1959 Corvette: Service Bulletin: Excessive Driveline Vibration

Subject: Excessive Drive Line Vibration

Model and Year: 1959 Corvette

Source: General Motors of Canada Service Bulletin

The propeller shaft and pinion angle and the elongation of the radius rod mounting bracket hole is shown in Fig. 44.

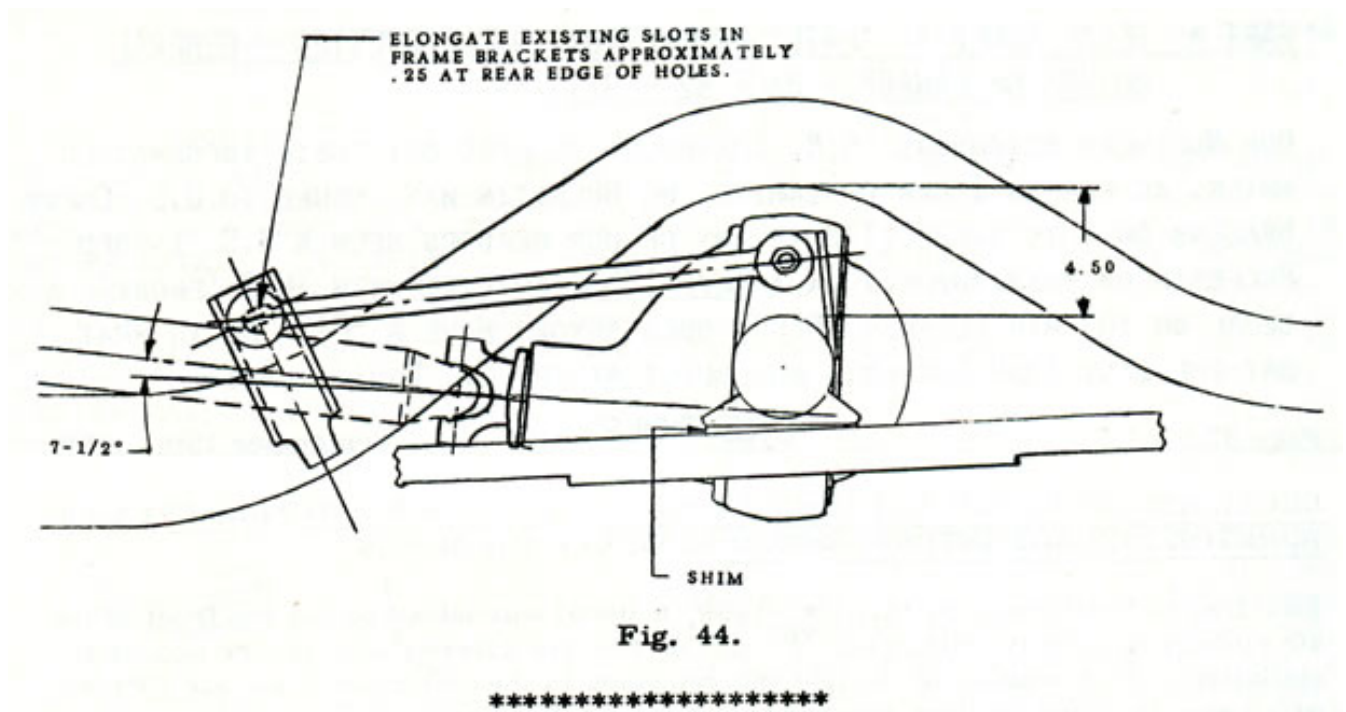
If excessive drive line vibration is encountered on the 1959 Corvette, it is probably due to excessive rear U-joint angle. Elimination of the vibration can be accomplished by installing either a 2° or 3° shim between the axle pads and springs on both sides, with the thick side to the front.

The nominal angle of the rear U-joint is 7-1/2°. Care should be taken in not going under 7-1/2° due to interference at full bump position.

1. Load vehicle until distance between the axle housing and the frame rail kick (metal to metal) is 4-1/2". Retaining the vehicle in this position, the angle of the propeller shaft and pinion nose can be measured, as shown in the 1958 Passenger Car Shop manual.

2. The radius control rods should be disconnected before installing the shim. Before re-attaching the radius control rods, elongate the radius rod frame mounting hole 1/4" rearward if necessary to eliminate any interference between the radius control rods attaching bolt and mounting bracket. Shim part #3722797 (2 °), or #3744488 (3 °), or their equivalent may be utilized. The locating tab on the above shims should be removed to allow the shim to lie flat.
